Hurricane Planning Commission Meeting Agenda

May 22, 2025
6:00 PM

Agenda Date:	05/22/2025 - Planning Commission
Application Number:	ZC25-13
Type of Application:	Zone Change
Action Type:	Legislative
Applicant:	James Cheney/JACI Properties
Agent:	Gerold Pratt
Request:	Approval of a Zone Change from RM-2 to HC.
Location:	40 N 2480 W
Zoning:	Multiple Family RM-2
General Plan Map:	Multifamily
Recommendation:	Recommend approval to the City Council.
Report Prepared by:	Fred Resch III

Agenda Date:	05/22/2025 - Planning Commission
Application Number:	PSP25-12
Type of Application:	Preliminary Site Plan
Action Type:	Administrative
Applicant:	Western Mortgage and Realty Co.
Agent:	Karl Rasmussen
Request:	Preliminary Site Plan Approval
Location:	3150 W State St.
Zoning:	Highway Commercial
General Plan Map:	General Commercial (HC)
Recommendation:	Approve subject to staff and JUC comments.
Report prepared by:	Fred Resch III

ZONING PLAN
FOR
DESERT FIELDS REMAINING PARCEL
JAMES CHENEY
CITY OF HURRICANE, WASHINGTON COUNTY, UTAH

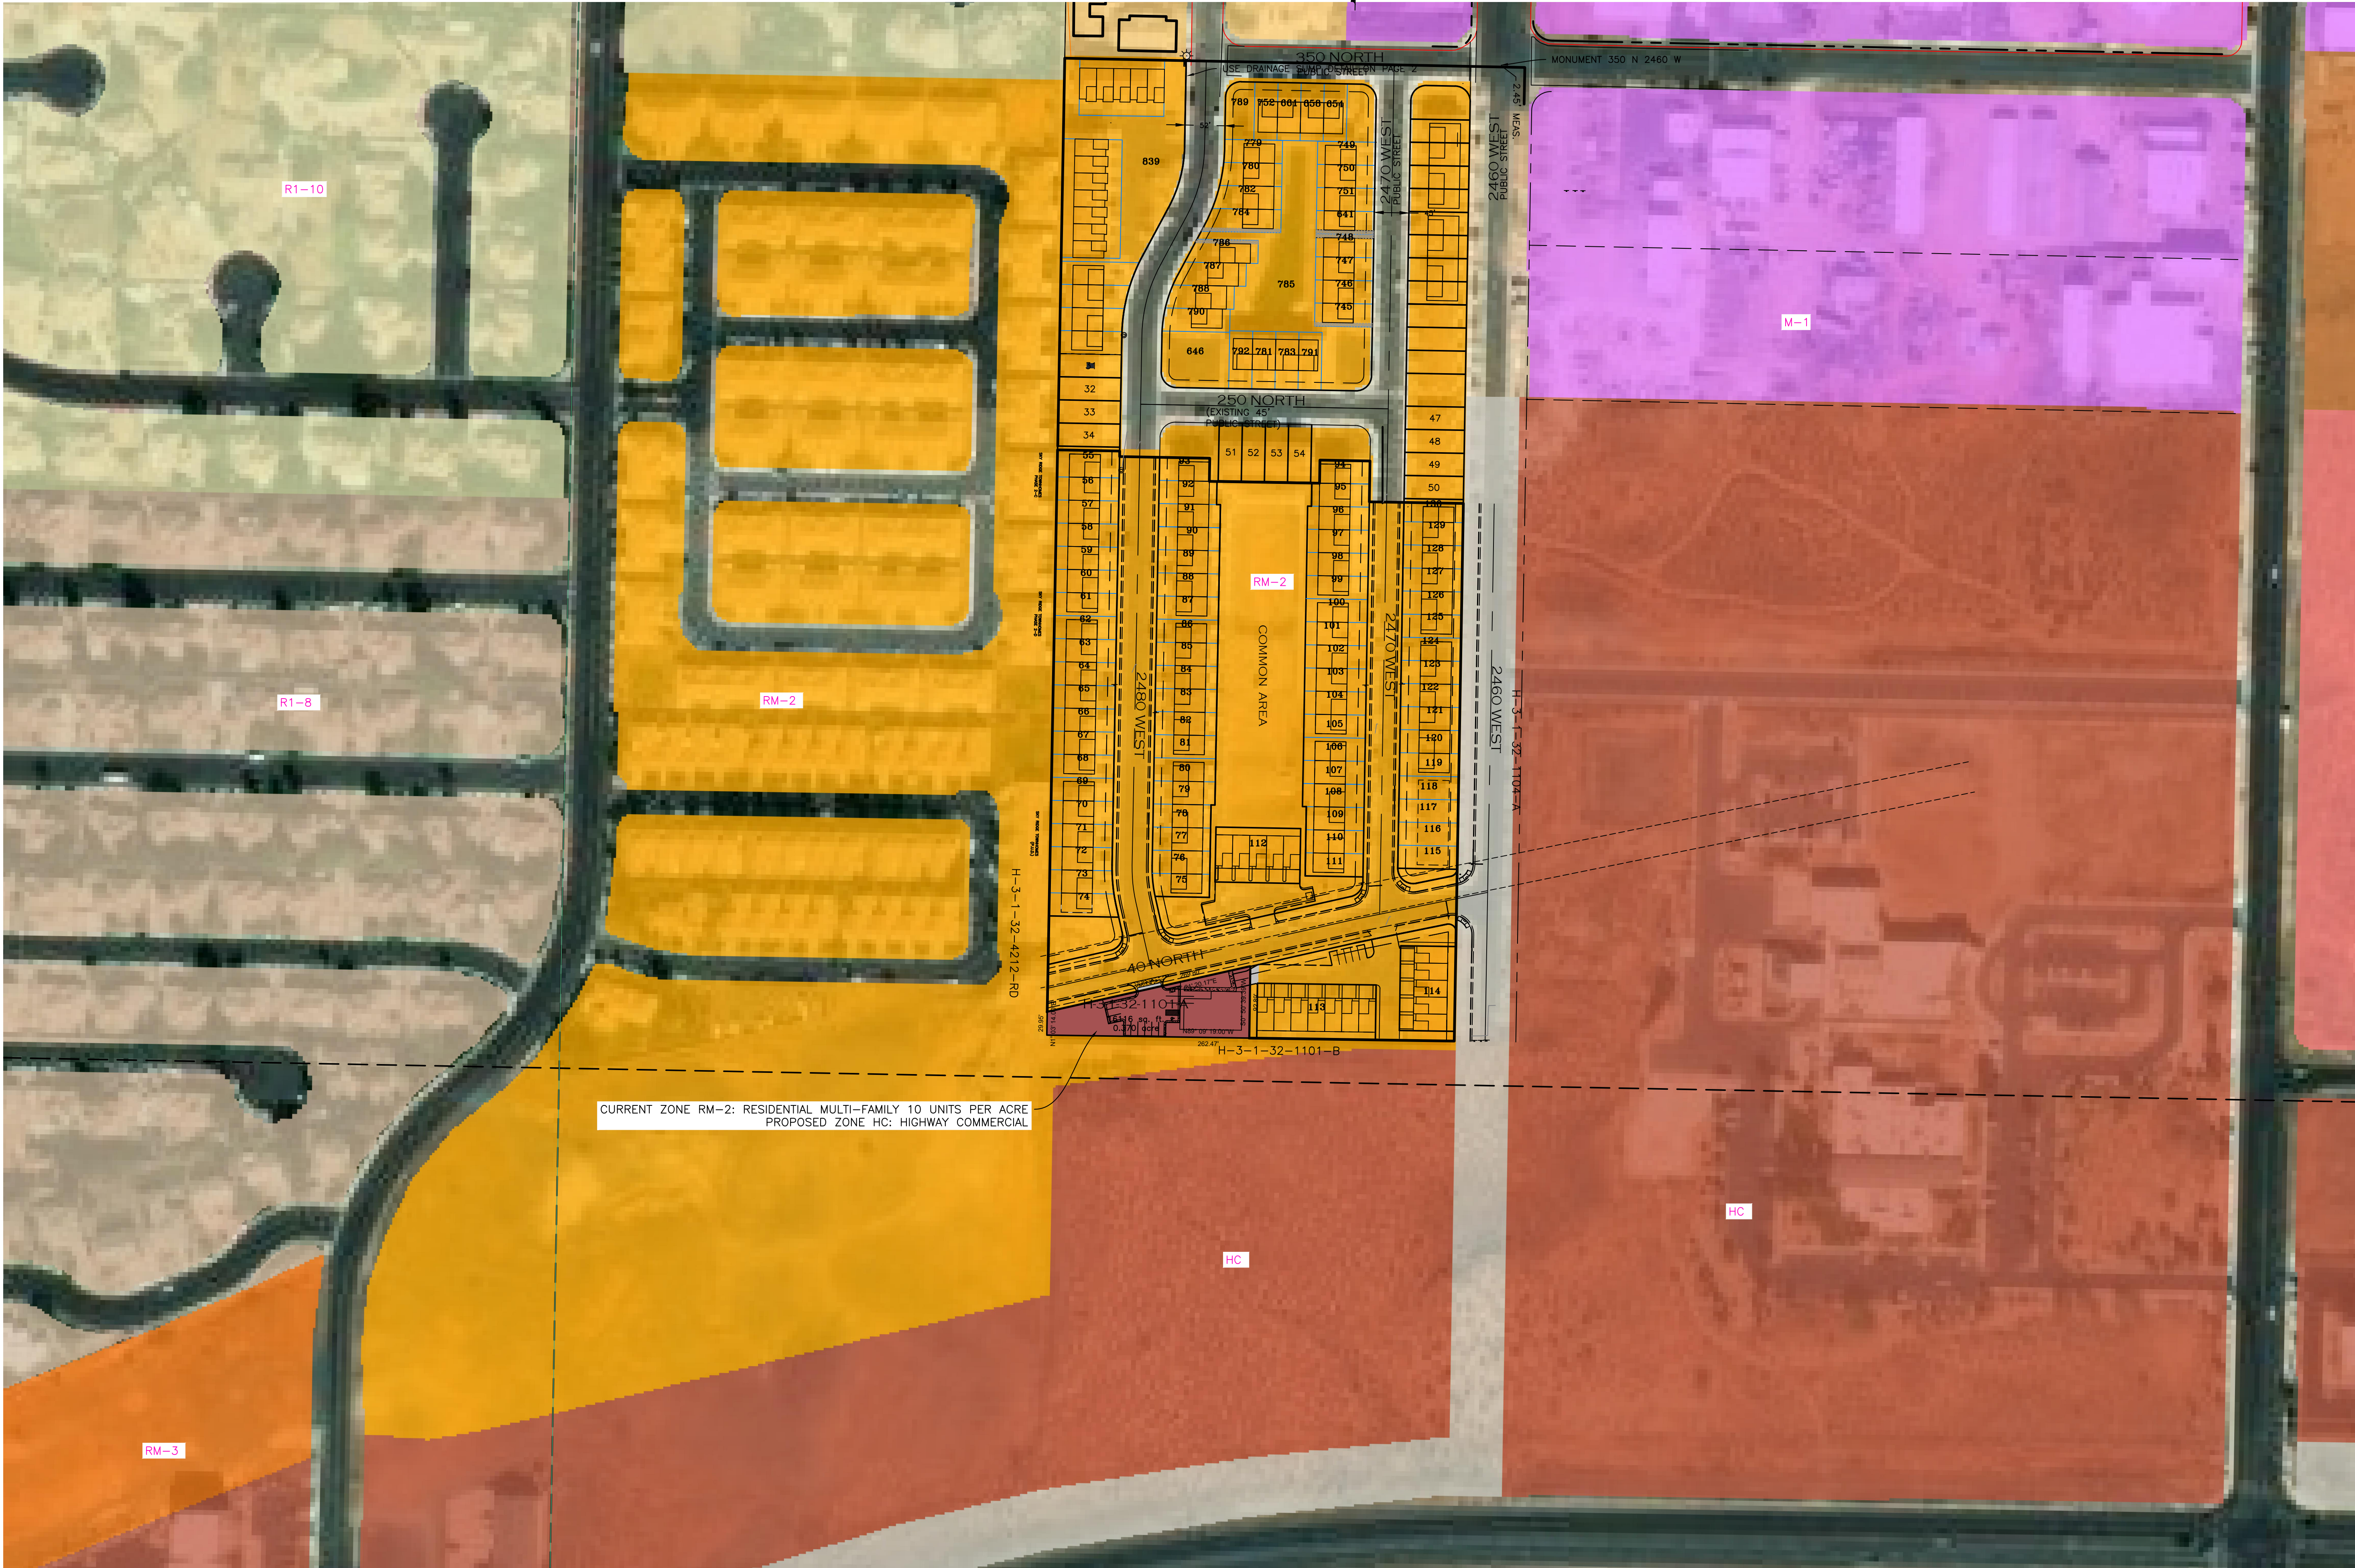
Engineering: This parcel is near the shared boundary between the general commercial and multifamily zones on the general plan. HCC 10-11-4(b) specifies that road centerlines and property lines shall be construed to be the boundary of a zone when such zone boundary is approximately upon the centerline of a street or along a property line. The requested commercial uses can easily be harmonious with the existing neighboring multifamily and commercial uses. Enumerating negative effects of the zone change will be subjective. However, making this parcel the same zone as the neighbor to the south appears to be a boon. The owner of the subject parcel should be reasonably capable of providing themselves adequate facilities wherever they lack. Engineering supports the zone change if the same motion tidies the sliver of RM-2 zoning between it and the parcel to the south.

As noted in the Engineering comments, there appears to be a narrow sliver of RM-2 zoning on the parcel immediately south of the subject property, as shown on the current zoning map. If this zone change is approved, that sliver would remain isolated. This zoning anomaly may have been intentional, possibly reflecting a previously planned alignment of 100 North, or it may be a mapping error. Regardless, per Hurricane City Code section 10-11-4, the Zoning Administrator has the authority to clarify zoning boundaries to align with physical features such as property lines where appropriate. If the proposed zone

change is approved, the Zoning Administrator will direct the GIS Department to adjust the zoning boundary accordingly to follow the property lines and eliminate the isolated sliver.

PRELIMINARY SITE PLAN FOR:
ZION REGIONAL MEDICAL CENTER
LOCATED IN SECTION 6, T42S, R13W, S.L.B.&M.
HURRICANE CITY, WASHINGTON COUNTY, UTAH

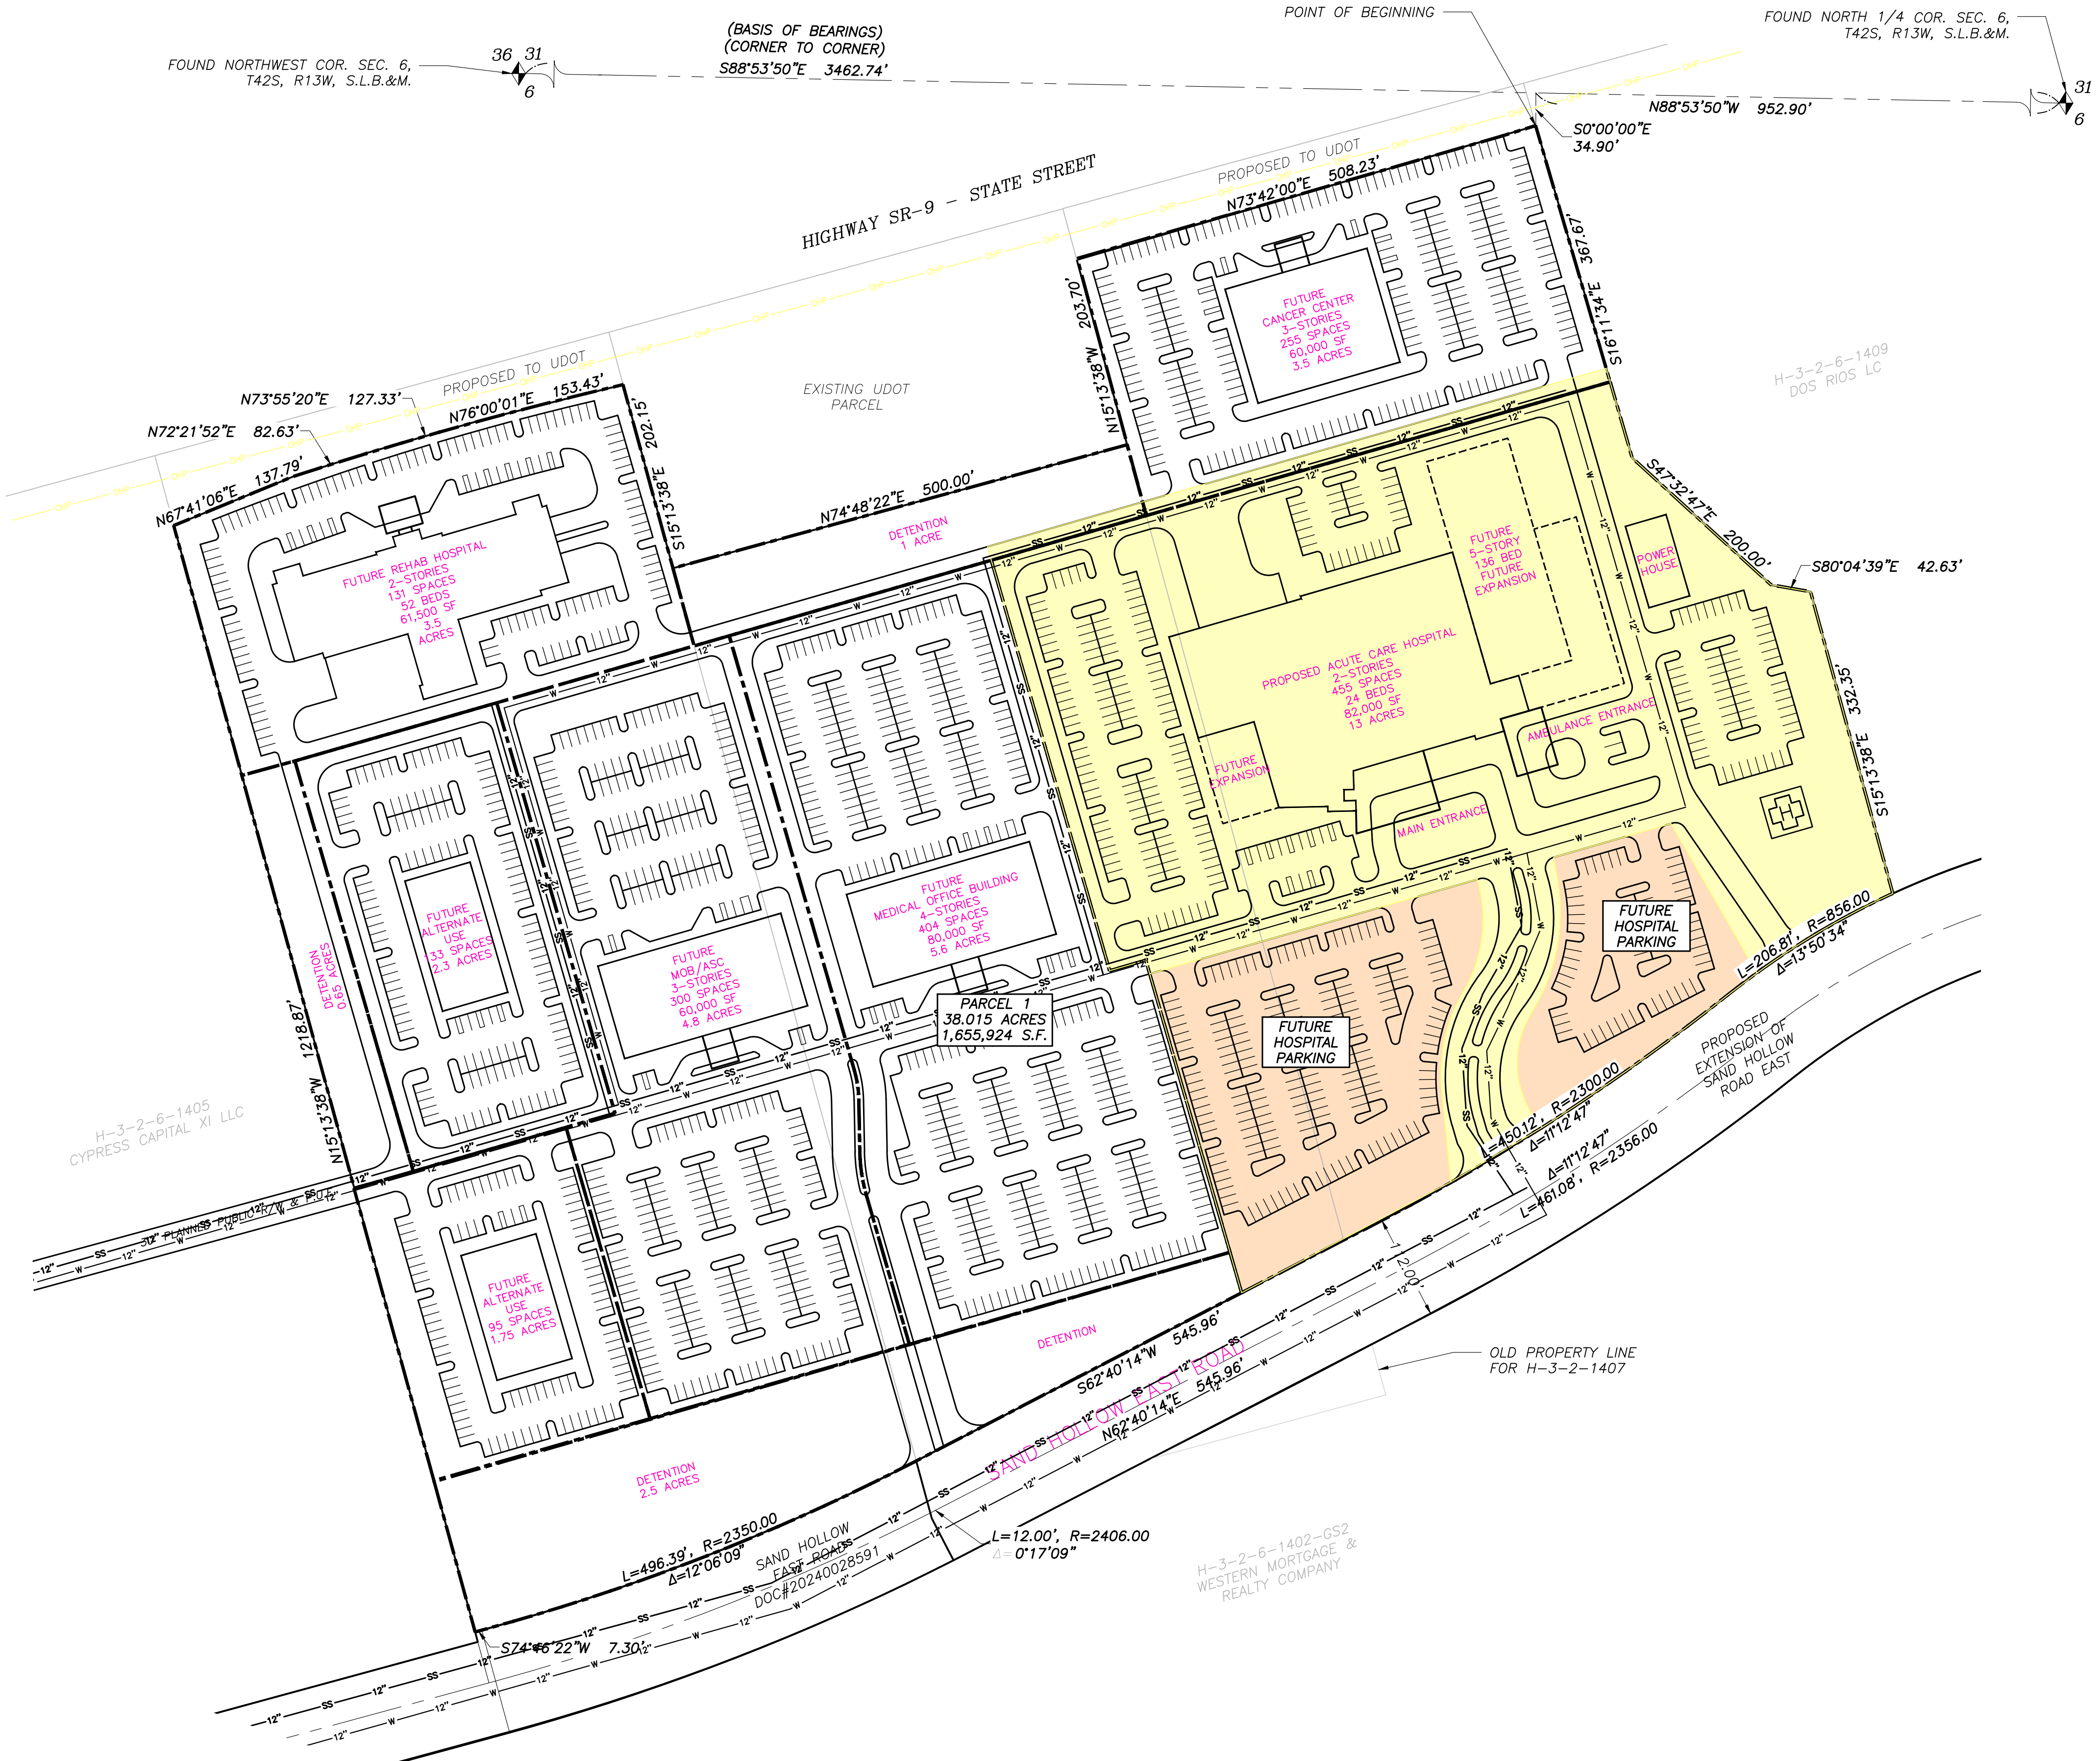
2. **Power:** Power line will need to be designed and extended along Sand Hollow East roadway to the far side of the property. Provide load calculations on full development. This requires the applicant to find like medical centers and provide at least 2 examples of the power usage. (fully developed). Easement along SR-9 for future transmission line must be signed over to Hurricane. Typical easement for this power line is 60'. This easement is a continuation of UAMPS easement size. Medical Center needs to have further discussions with Hurricane City Power for off-site work, including the upsizing of distribution or transmission lines. All details and/or contracts will be worked out at this time.

3. **Water:** This will need a water model. In your planning, consider looping to the line crossing under SR-9 at 3400 W
4. **Streets:** No comment.
5. **Sewer:** No comment.

6. **Engineering:** Large diameter storm drain pipes are depicted on the Stormwater Master Plan along SR-9 and across this site and stormwater pipes in Sand Hollow Road East have been depicted in Gateway at Sand Hollow PID plans (HCS 3.4.1(4th paragraph)). Off-site drainage must be conveyed safely through the site (HCS 3.4.1(10th paragraph)). The medical center site must account for access (vehicular and utility) to the eastern property. The anticipated grading for Sand Hollow Road East will make direct access from Sand Hollow Road East to H-3-2-6-1409 challenging. (see HCS 2.1(2nd & 3rd bullets) & 3.2.4.2(g & k)). The site will require it's own traffic impact study to advise on the needs at the SR-9 and 3400 W traffic signal, other key intersections, and comment on shared access (HCS 3.9.2). Study of the best vertical and

horizontal alignment for Sand Hollow Road East should be prioritized (HCS 3.2.4.2(c)). The site is on the higher side of the master planned Dixie Springs (3140) water pressure zone. A water network hydraulic analysis must be done and advise how the water design should look (HCS 3.6.9). Generally, the minimum separation for intersections along arterials is 650' min (HCS 3.2.4.3, see also table 11 of the Transportation Master Plan). We question the need for dedicated ambulance access. Accurate depictions of the neighboring properties must be provided (HCC 10-7-10(d)(2)(a)(7)). It appears the eastern neighbor must contribute right of way to continue the proposed road alignment and properties owned by the applicant will become strange remainders between the proposed road and existing ridge. Existing property lines must be considered with choices made by this project. A master planned trail must be constructed with the development. coordination with UDOT must occur. The applicant must propose connections to the existing systems. "required improvements shall extend from the nearest acceptable point of existing improvements." HCS 2.1(bullet 1). It appears the intersection of SR-9 and 3400 W and the intersection of Gateway Boulevard and Sand Hollow Road are the nearest acceptable points for most utilities and access. "Wherever possible, all street intersections should intersect at ninety degree angles." HCS 3.2.4.2(a). HCS 3.2.4.11(e) limits vertical alignment options at intersections on road classifications at or greater than major collector. A roundabout has been proposed as the traffic control for this intersection. Should be explored in the Traffic Impact Study. Hurricane City's Transportation Master Plan depicts a minor collector with 12' trails on both sides near the proposed 30' public right of way alignment. Engineering supports replacing said minor collector with private shared drive aisles and public utility corridors (easement), or modified public street cross sections, if a five lane cross section and the master planned trails are provided by Sand Hollow Road East (HCC 10-2-3 & HCS 3.2.2/3.2.4.2(f)). Agreements with the neighboring property owners must be disclosed during construction plan review (HCC 10-7-10(D)(3)(e)). City staff can help facilitate meetings. The site plan fails to provide preliminary grading data (HCC 10-7-10(d)(2)(a)(2)). Geologic hazards exist in the area and the geotechnical investigation report must address them (HCS 4.5.4 & HCC 10-28-2, the Hurricane City ordinance was recently updated please ensure the most current version is obtained). The off-site work (e.g., 3400 W and Sand Hollow Road East) needed to support this project is significant enough to be project(s)/construction plan(s)/phase(s) of their own (HCS 2.2.3).

7. **Fire:** Approved.
8. **Phone:** [No comments received.]
9. **Cable:** [No comments received.]
10. **Gas:** Show where gas is being proposed location and gas drops/loads needed.
11. **Water Conservancy:** Washington County Water Conservancy District hereby acknowledges that based on the information provided, the plan adequately mitigates interference with district facilities and property interests. The District reserves the right to rescind this acknowledgement if additional information becomes available. The district has not determined whether water will be available for this development and does not hereby make any guarantee of water availability. In addition, the development must conform with applicable district requirements, including but not limited to payment of fees.

The submitted site plan indicates a total of 1,673 parking stalls across the entire campus. The proposed acute care hospital is shown with 160 beds and 455 dedicated parking spaces, which meets the parking requirements for that use. Some of the future phases of the development may require additional detail to verify compliance with applicable parking standards at the time of their submission. Given the nature of the development and the potential for shared parking among various uses on the campus, staff would recommend, or be supportive of, a parking modification study. Such a study could justify a reduction in the total number of required parking stalls, if requested by the applicant, by demonstrating efficiency through shared-use parking.

For a building of this size, approximately 5 loading parking stalls will be required (HCC 10-34-6(E)), and it appears enough space has been provided for them but it will need to be verified on the final site plan.
